UNITED STATES PATENT AND TRADEMARK OFFICE

APPLICATION NO.	FILING DATE	FIRST NAMED INVENTOR	ATTORNEY DOCKET NO.	CONFIRMATION NO.
10/813,049	03/31/2004	Robert Ames	4548-002	4862

Office Action Summary

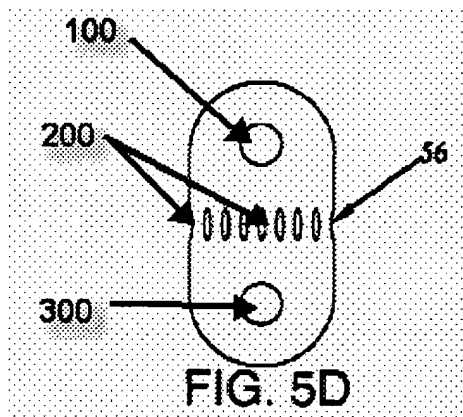
Claims 1-5 are rejected under 35 U.S.C. 102(b) as being anticipated by Anderson (U.S. Patent 5,913,670) (see marked-up figure below).

Claim 1. Anderson discloses (fig.5d) a breakaway connector, comprising: first connecting means (100) for connecting with an external device; and second connecting means (200, 300) for maintaining a length of rope in a bent state and for holding the rope until a load applied to the rope reaches a predetermined level at which said second connecting means completely release

the rope, said second connecting means comprising a breakaway element (200) that will fail under said load of said predetermined level to release the rope.

Claim 4. Anderson discloses the breakaway connector of claim 1, wherein said second connecting means further comprise guiding means (56) for guiding the rope around said breakaway element to define a bent section of the rope at said breakaway element and first and second sections of the rope on opposite sides of the bent section.

Claim 5. Anderson discloses the breakaway connector of claim 4, wherein said guiding means comprise a passage (passage of 56) and said breakaway element is positioned in said passage to divide said passage into first (left most channel of 56) and second channels (right most channel of 56) for accommodating the first and second sections of the rope, respectively.
